**Report to the Future Melbourne (Planning) Committee**

**Ministerial Referral: TPMR-2018-11  
13-23 Spring Street, Melbourne (Mercure Melbourne Treasury Gardens)**

7 August 2018

**DELEGATE REPORT****MINISTERIAL PLANNING REFERRAL**

#### Height

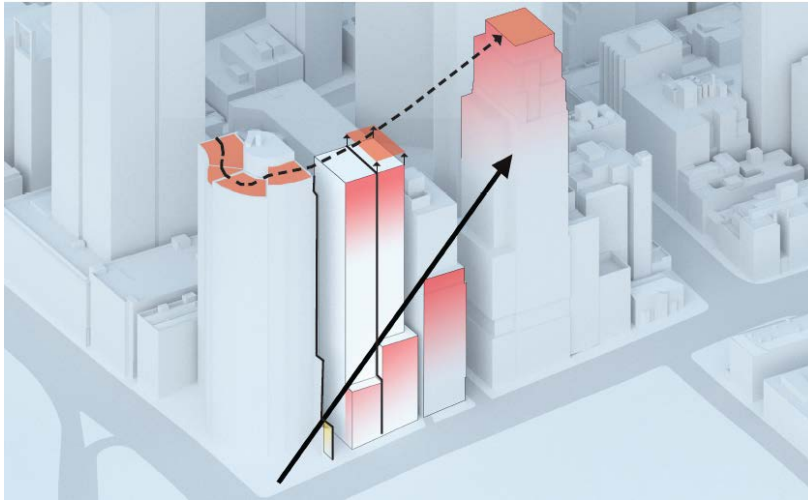
The tower has a total height of 125.22m (148.22m AHD) measured to the top of the parapet from the centre of the site frontage to Spring Street.

**Preferred and modified tower floorplate diagram (Source: Bates Smart Pty Ltd)**

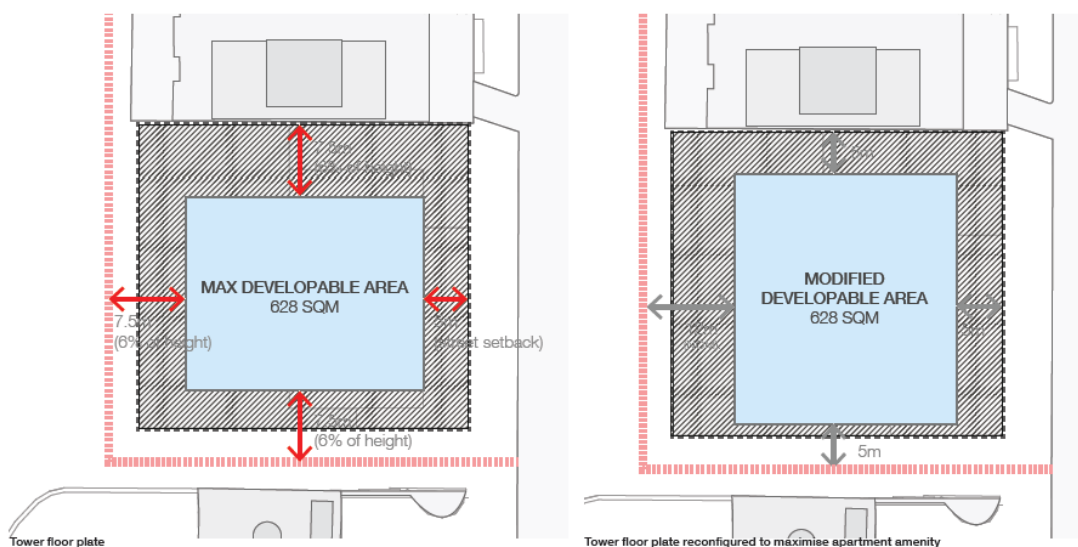
The preferred requirement for the tower floorplate is determined by the preferred requirement for side and rear setbacks (7.51m) and the modified requirement for building setback above the street wall (5m), which provides a developable area of 628m<sup>2</sup> for the subject site.

The modified requirement relates to towers exceeding 80m in total height and states that the floorplate may be adjusted in terms of its location and/or shape but must not:

The development satisfies the modified requirement for the tower floorplate as shown in the illustration below.

The location and shape of the tower has been modified so that the longest face addresses Treasury Gardens

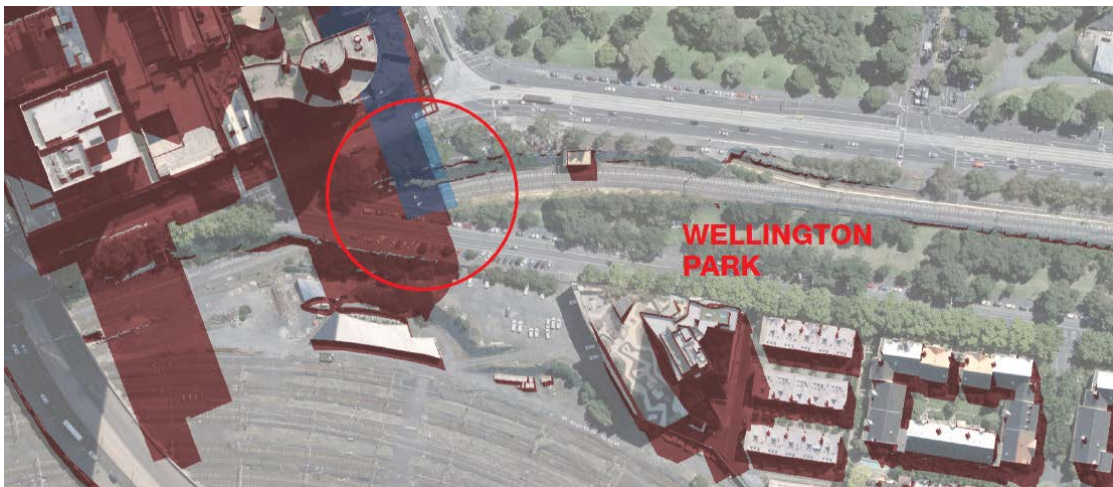
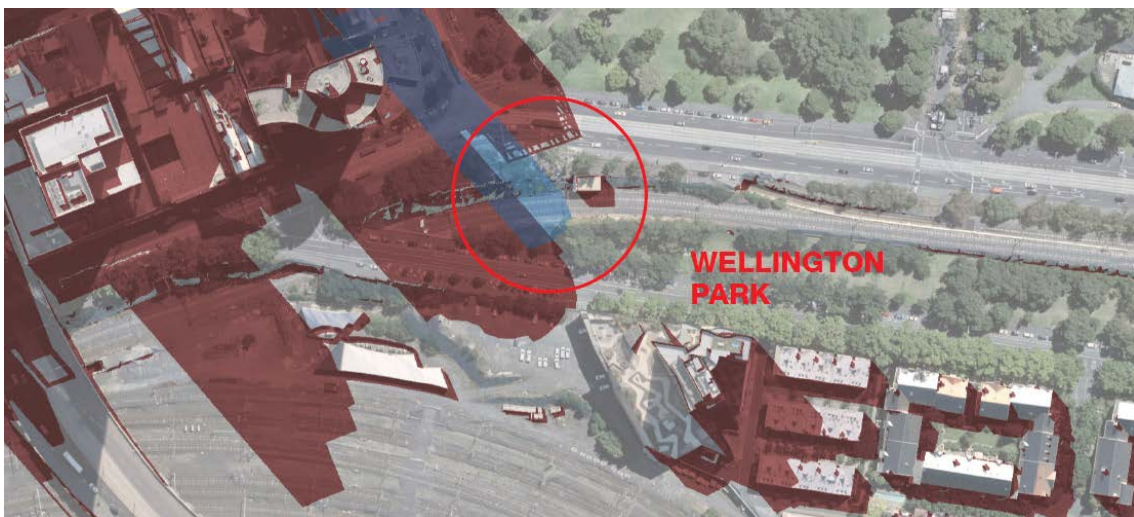
DDO10 states that a permit must not be granted for buildings and works that cast any additional shadow across a space listed within Table 2 during the hours and

dates specified, unless the overshadowing does not unreasonably prejudice the amenity of the space.

Aerial photo of raised courtyard at the Shell House (Source: Google Maps)

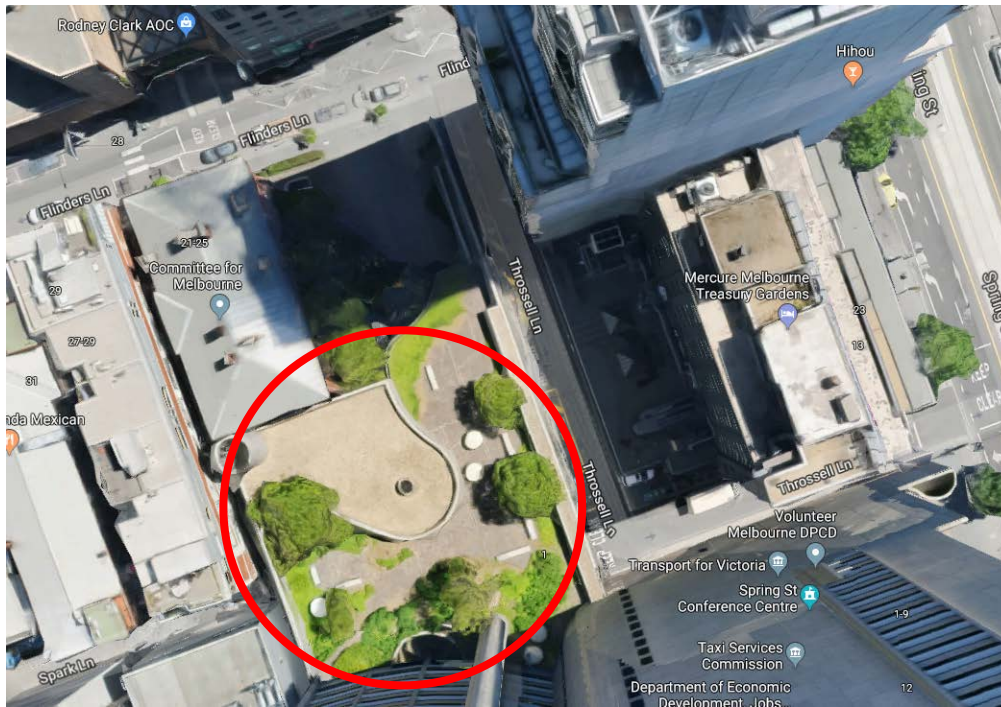
In the event that the adjoining courtyard is developed with a 5m setback from the centre of the lane, this will provide a total separation distance of 14.91m and 18.19m, which is acceptable.
